Access Compliance Report

Public Rights-of-Way

(Curb Ramps)

Intersection ID: 10036734	Main Street: S_DAVIDSON_ST	Cross Street: STONEWALL_ST	Location: NE
ADA ID: EDB947865079	Ramp Type: Directional1	Initial Pass/Fail: Pass	Overall Compliance: No
Severity Score: 0			
Codes/Mitigation Info/Possible Solution		Field Measurements/Component Compliance

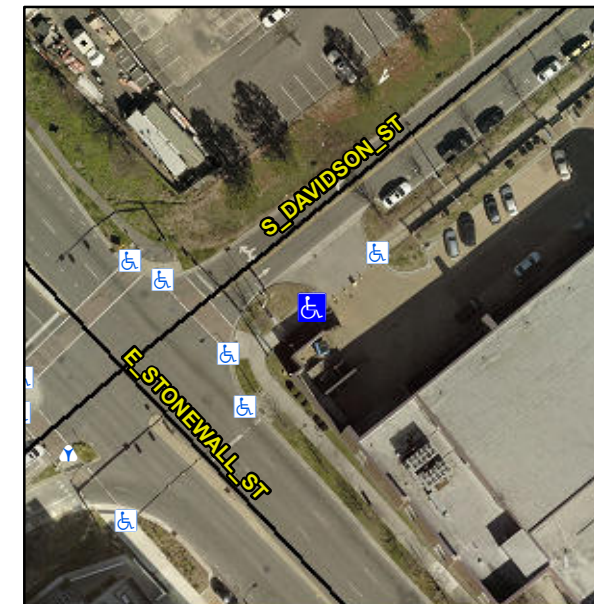
Possible Solutions:

Remove & Replace Entire Ramp.

PROW/ADA:

R304.5.2
